Sarah B. Jones, Acting Environmental Review Officer
Regional Groundwater Storage and Recovery Project
San Francisco Planning Department
1650 Mission St., Suite 400
San Francisco, CA 94103

Restore Hetch Hetchy appreciates the opportunity to comment on Case No: 2008.1396E – the Regional Groundwater Storage and Recovery Project (Project). As currently proposed, we believe the proposed project does not adequately address groundwater opportunities within San Francisco’s service territory and fails to bring San Francisco and its customers into compliance with federal law.

Re: San Francisco Public Utilities Commission Regional Groundwater Storage and Recovery
 Project Draft EIR, San Francisco Planning Department File No. 2008.1396E

Morgan Lewis hereby submits the comments of our client, Cypress Lawn Memorial Park (“Cypress Lawn”), on the Draft Environmental Impact Report (“DEIR”) for the San Francisco Public Utilities Commission (the “SFPUC”) Regional Groundwater Storage and Recovery project (the “GSR Project”). Pursuant to Ms. Jones’ e-mail of May 21, 2013, the San Francisco Planning Department and the SFPUC have agreed to accept and respond to comments from Cypress Lawn submitted on

EXHIBIT B

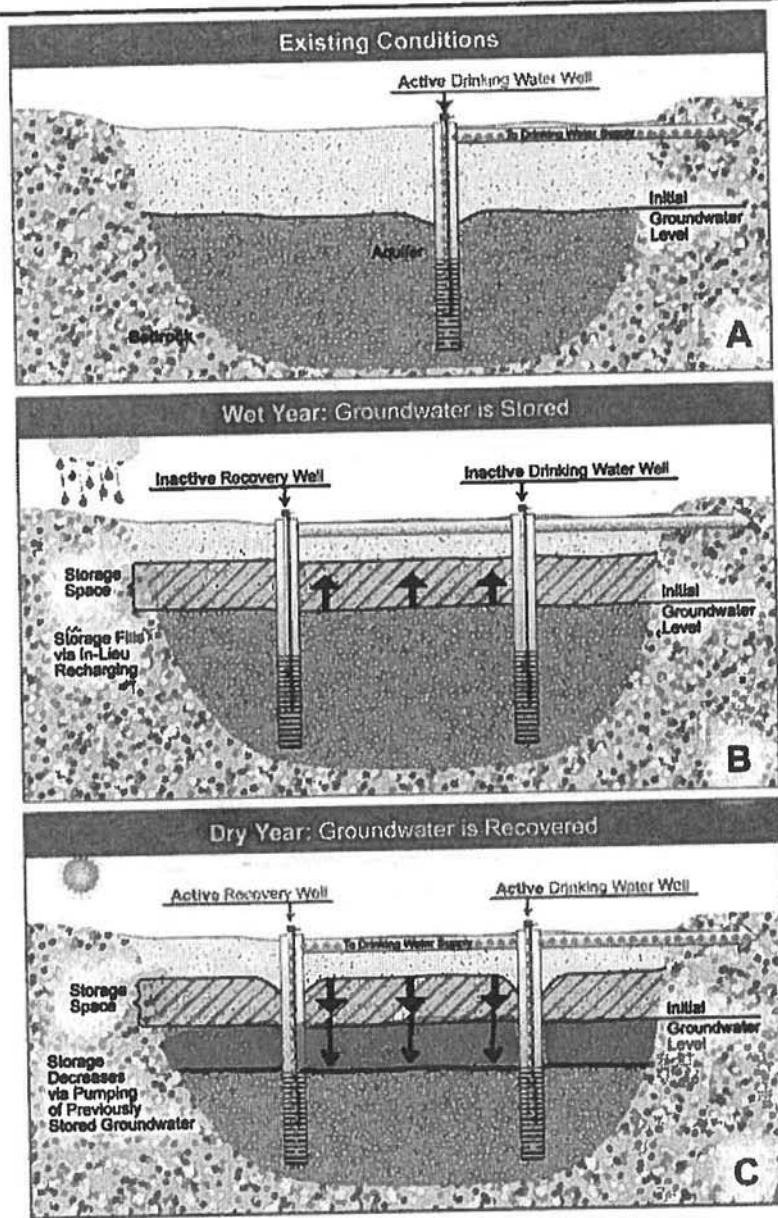
The proposed operation of the GSR Project Storage Account is not based so much on the premise of a “Positive Balance” as it is on the premise of “Borrowing/Payback.” That is, during dry/take periods, the SFPUC will significantly drawdown the Westside aquifer by pumping amounts that are in excess of the additional water added to the aquifer as a result of the Partner Agencies’ forgone pumping. However, as part of the GSR Project, the SFPUC proposes over the long run to “payback” the groundwater it borrowed (via substantial drawdown of the groundwater table) through forgone pumping by Partner Agencies in subsequent wet/put periods, which over time should allow the groundwater table to eventually rebound.

¹⁶ See **Exhibit B** to this letter, “Modified Diagram of GSR Project,” attached hereto and incorporated herein by this reference, showing drawdown below stored amount.
